Detailed Site Plan
Departure from Design Standards
Dewey Property

DSP-19050
DDS-660

STAFF REPORT

SUBJECT: Detailed Site Plan DSP-19050
Departure from Design Standards DDS-660
Type 2 Tree Conservation Plan TCP2-042-2019-01
Dewey Property

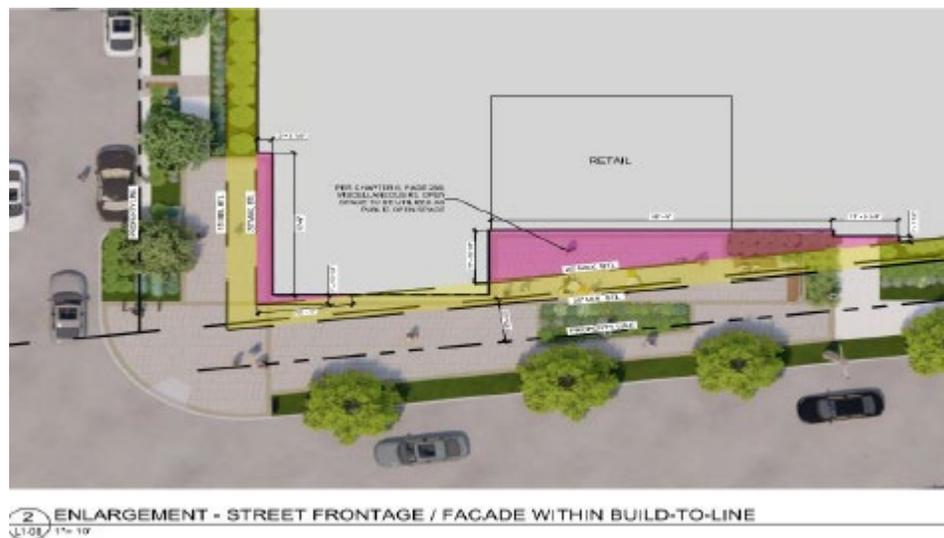
- c. **Streets and Frontage, Build-To Lines and Zones, Articulation (page 209-210)**—The TDDP establishes build-to lines that create a minimum and maximum distance a building can be from the face of the curb. As in many similar circumstances, the existence of public utility easements impact the location where buildings can be

constructed. There are two standards which the proposed development cannot conform to and which require an amendment:

Table 42: Minimum/maximum build-to line from Toledo Road is 20 feet/25 feet.

Table 43: Minimum/maximum build-to line from new B Street is 15 feet/20 feet.

The building façade is within the minimum and maximum allowances required by the TDDP for approximately 74 percent of the frontage along Toledo Road. The only area that does not conform is the retail area along Toledo Road, which was pulled away from the build-to line to help emphasize the public space. This public space will act as a focal point, and ties into the elements along America Boulevard to the south. The east end of the southern façade also has encroached past the minimum build-to line to allow for residential stoops to further activate the Toledo Road frontage.

Road B is not intended to be activated like Toledo Road, which is a primary street. However, over 80 percent of the façade is within the build-to line along this frontage. The only area which is setback behind the build-to line (approximately 3 feet) is the corner of the building. This additional setback is intended to accentuate the corner and the entrance to the building, which allows a wider sidewalk and additional landscaping at the base of the building.

This TDDP standard also states that service entrances shall be at the rear of the building. Access to the rear of the building is limited by the proposed building and the SWM pond to the east. Therefore, the entrance to the loading area is directly from Road B. Staff recommends that the applicant provide a raised sidewalk and/or other pedestrian enhancements across this loading and adjacent parking garage entrance to improve the walkability of this frontage.

Staff recommends **approval** of this request for the deviations from the build-to line and to allow the service entrance not to be at the rear of the building. This is supported to provide greater pedestrian activity at a significant corner area.
